LIST OF PROPOSED CHANGES:

THE MEADOWLANDS - PROPOSED SITE PLAN CHANGES

BUILDING 1 & 2
 PROPOSED CHANGES - FLOOR PLAN

RETAINING WALL & PATIO OVERALL PLAN (ORIGINAL SUBMITTAL)

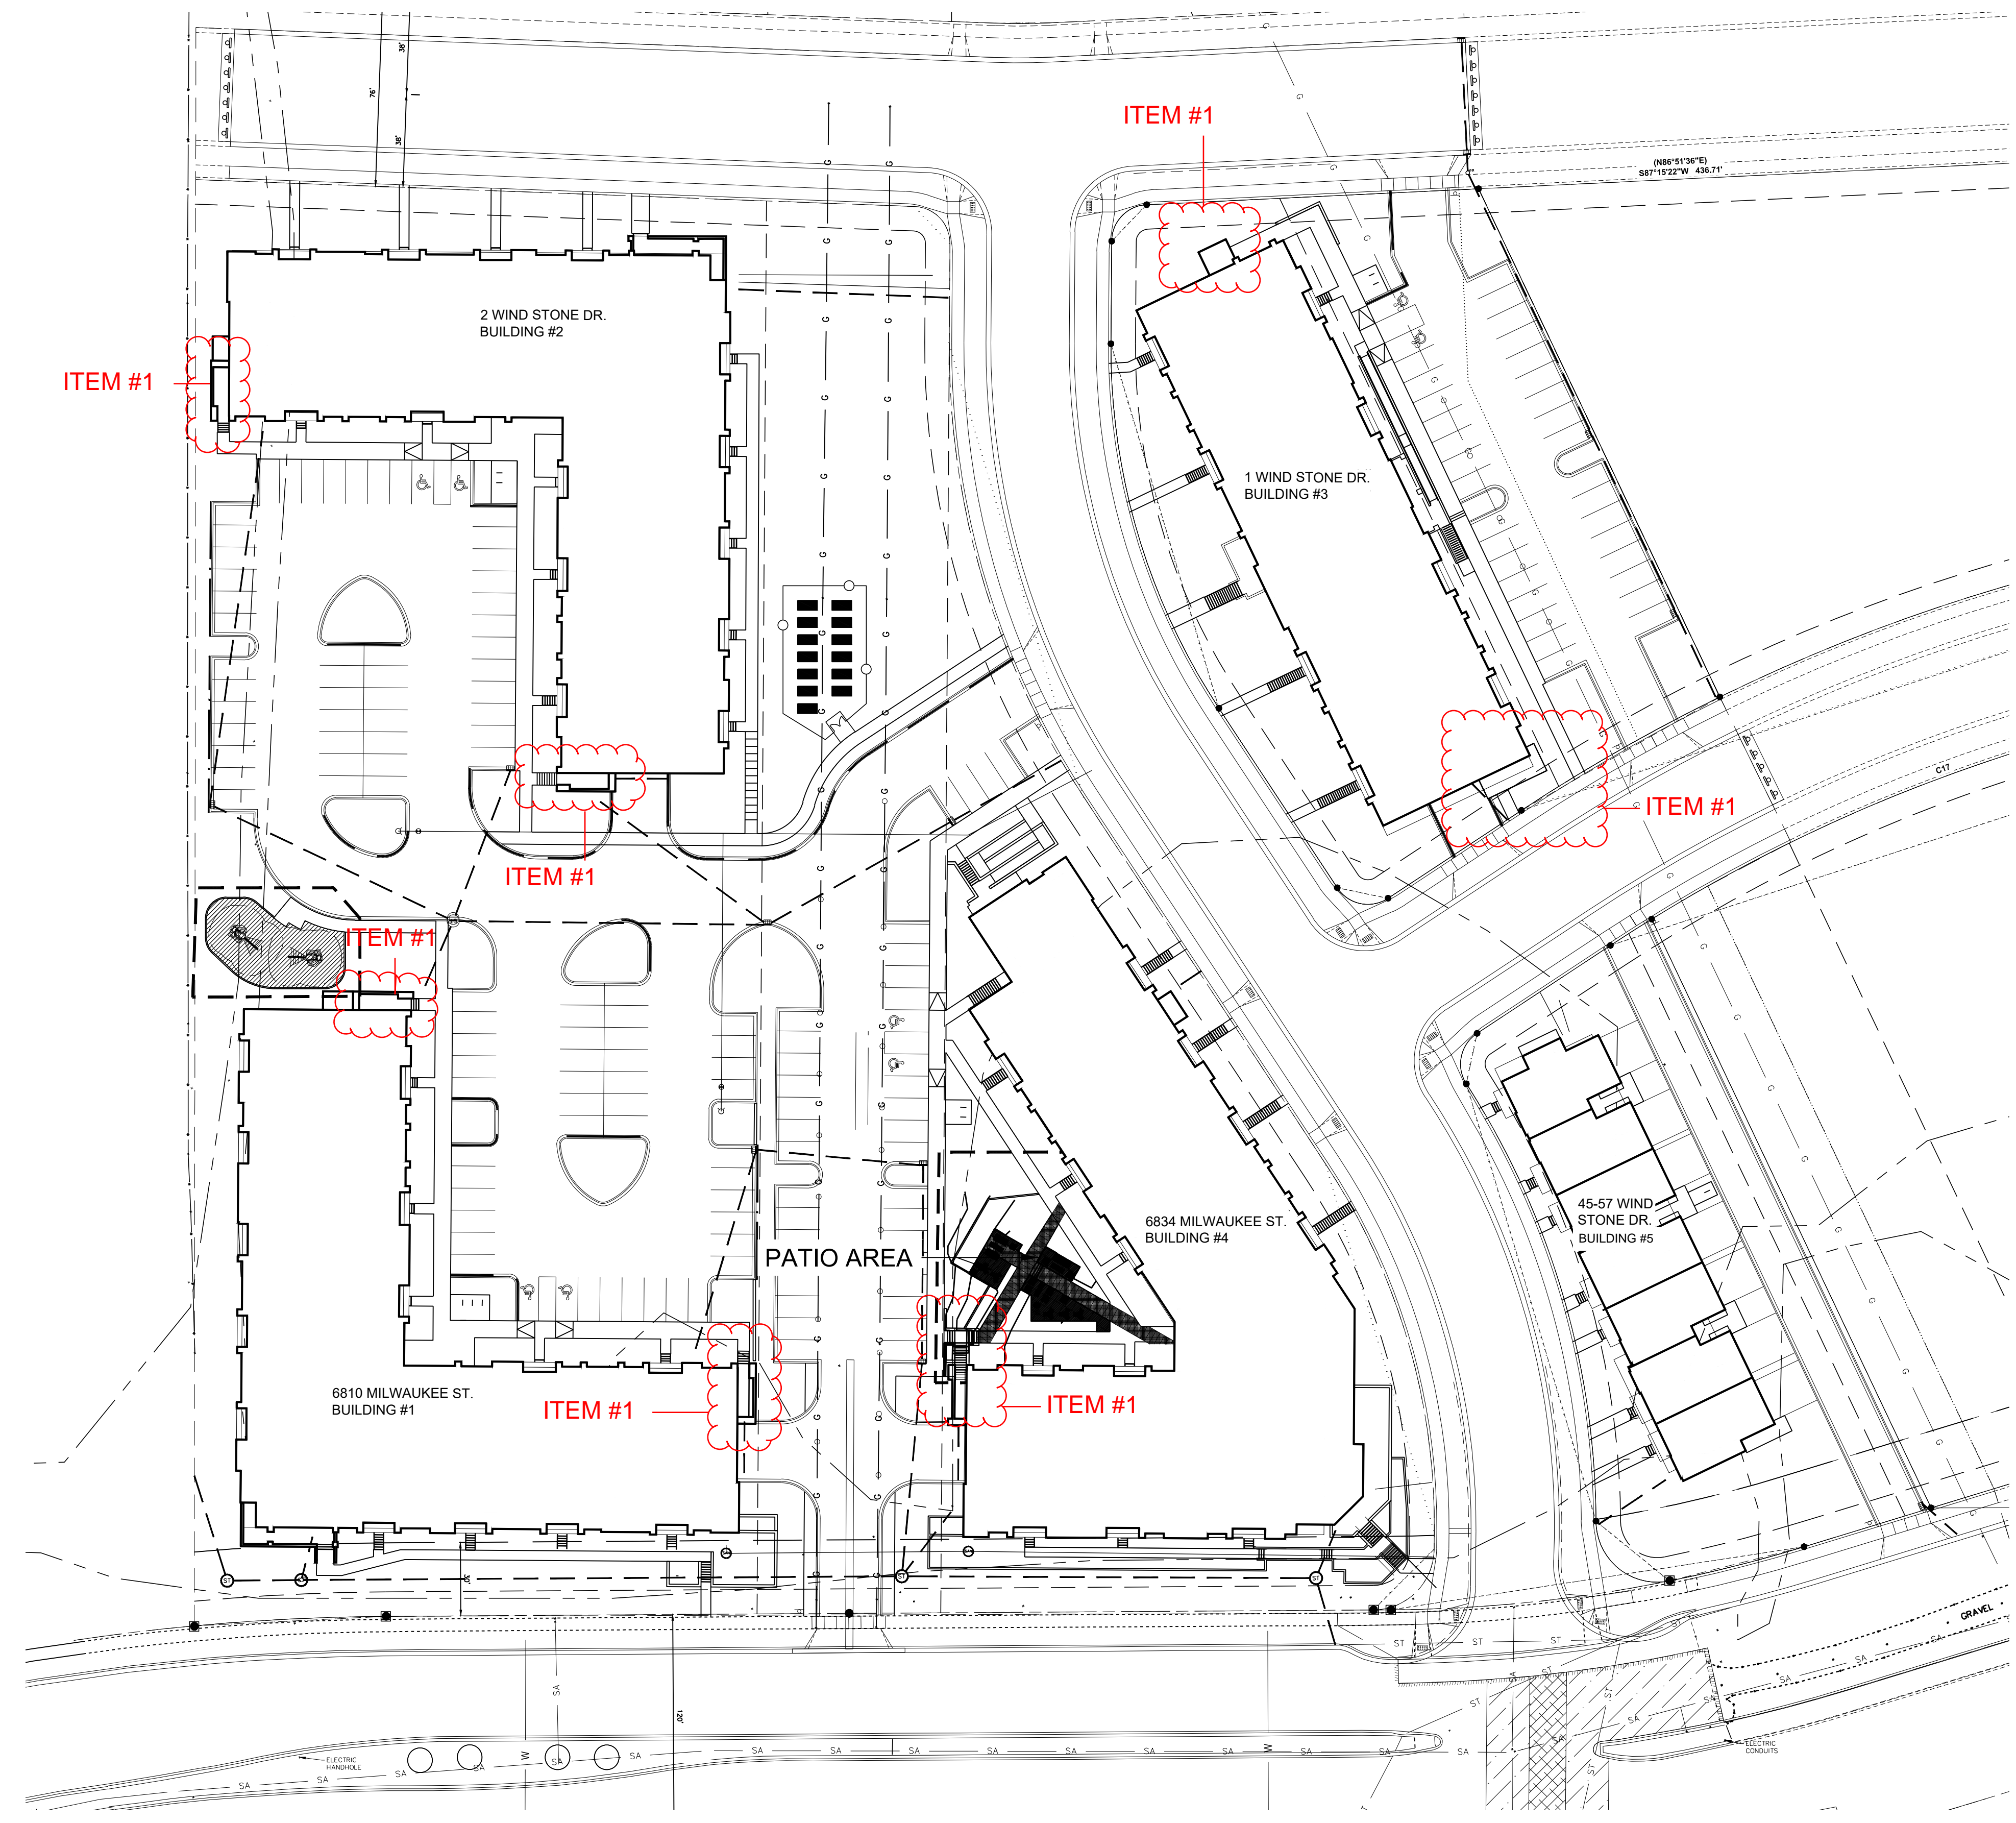
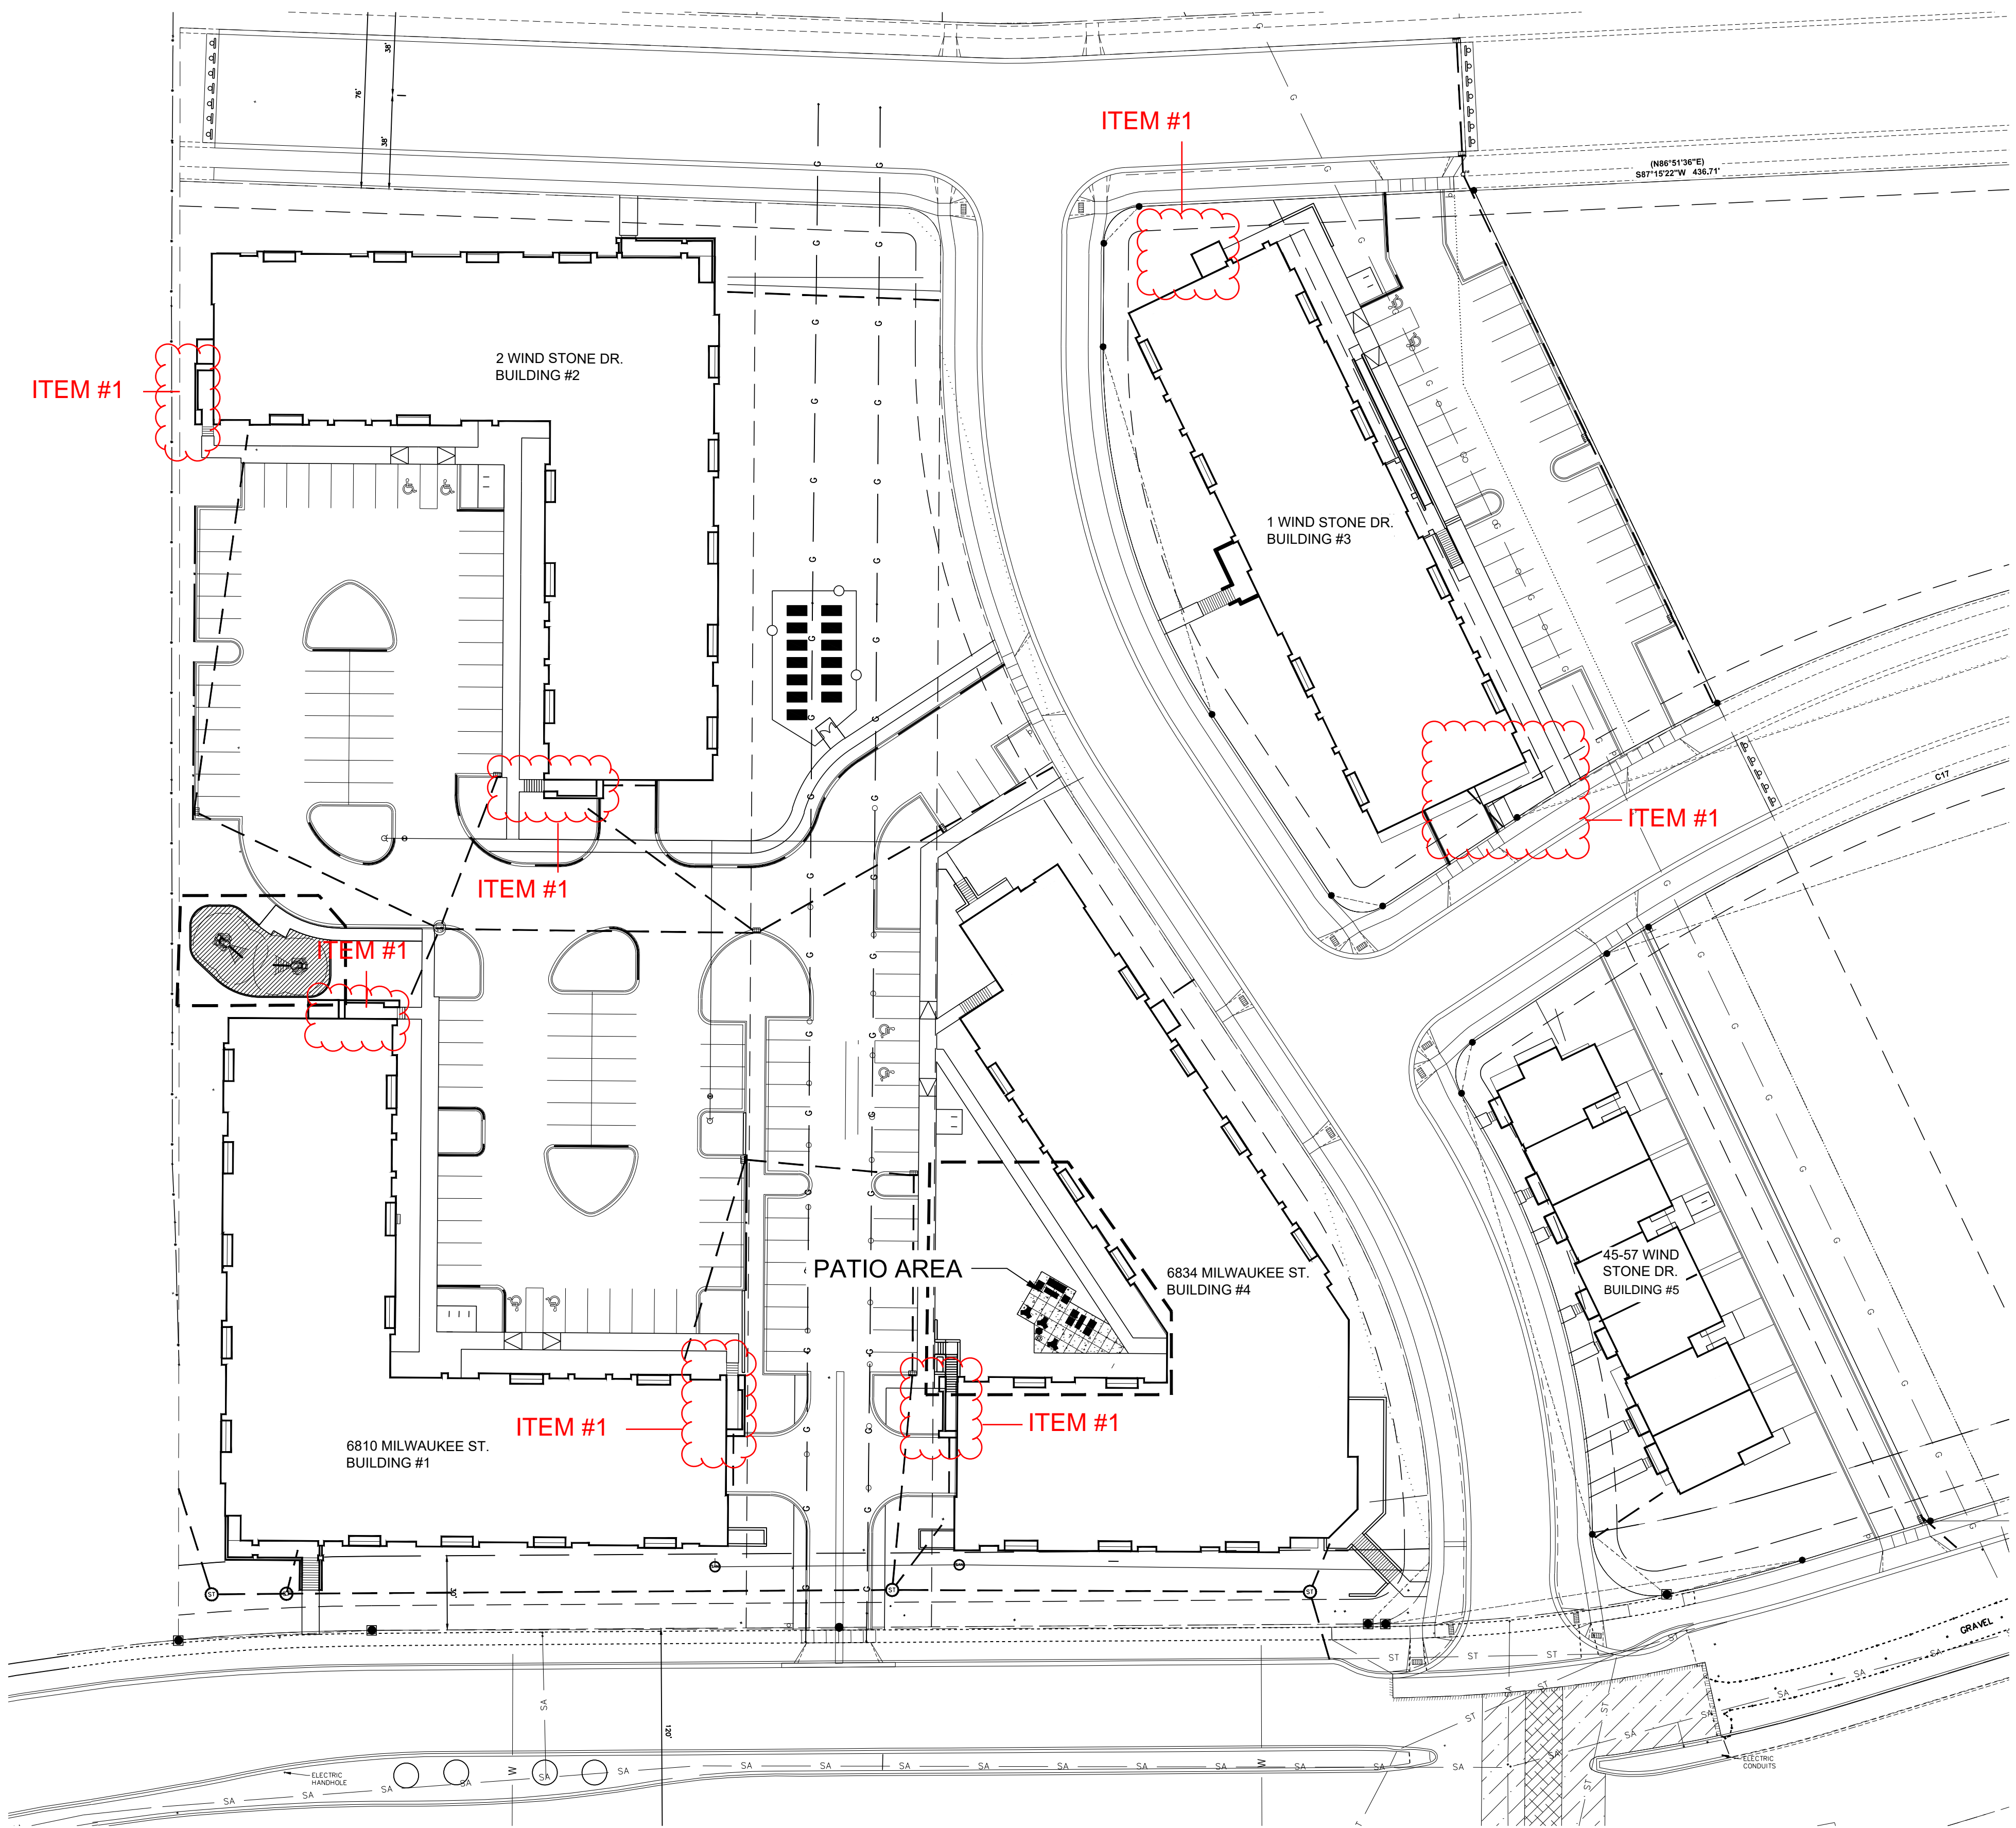
ITEM 1
REMOVE ROOF TO PORCH AT STAIR ENTRIES AND REDUCE PORCH SIZE (TYPICAL OF ALL END BUILDINGS).

- ITEM 1 REMOVE ROOF TO PORCH AT STAIR ENTRIES AND REDUCE PORCH SIZE (TYPICAL OF ALL END BUILDINGS).
